**PROJECT: Lakewood Elementary School  
Kitchen Renovation and Freezer Installation**

**ADDENDUM 3**

Revision to **Construction Documents**

**ISSUE DATE: March 29, 2023**

**CEILING PLAN**

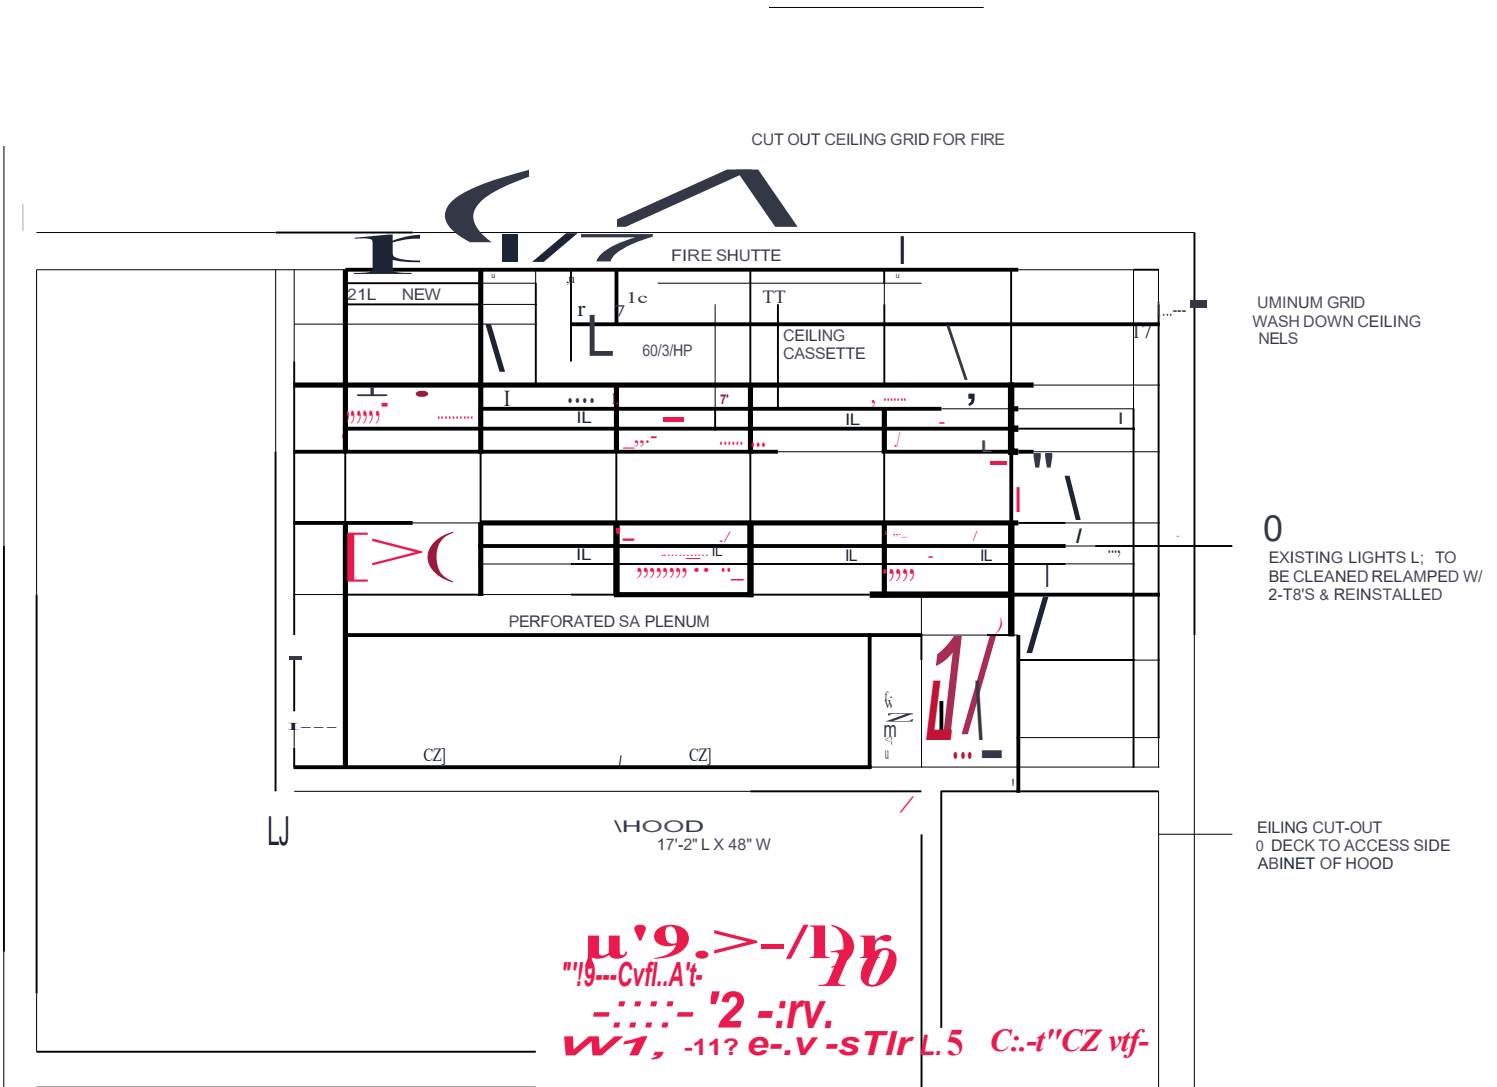
LAW ENDEER KITCHEN  
ADDRESS W1 #1.  
MARCH 24 2023

1. WIRE LIGHTS TO EXISTING 277 VOLT CIRCUIT
2. PROVIDE NEW LIGHT TO MATCH
3. SET DISC SWITCH FOR ROOFTOP CONDENSER & WIRE RUN POWER & COMM. WIRING TO CEILING CASSETEE IN 3/4" C
